# BMW Motorrad USA

## Service Information Bulletin

### **\*\*Notice of Recall 15V-537\*\***

**Subject:** Engine idle unstable

## ► Tightening clamp at throttle body

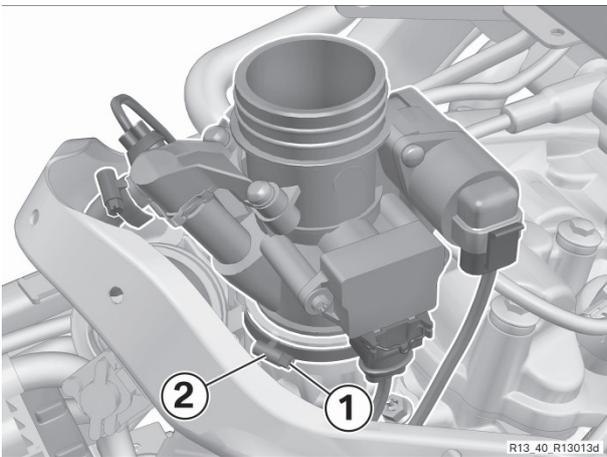
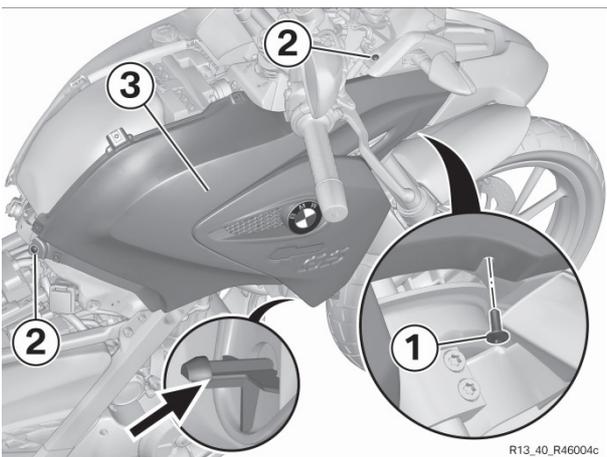
**Tightening the screw clamp of the throttle body with excessive force or unsuitable tools.**

Impaired engine running due to deformed intake stub.

- Use only a plain slotted screwdriver to tighten the screw clamp, without using additional tools.
- Do not use torque-amplifying tools such as an open-end spanner or a reversible ratchet for extra leverage.

- Slacken screw **(1)**.
- Position clamp **(2)**.
- Tighten screw **(1)**.
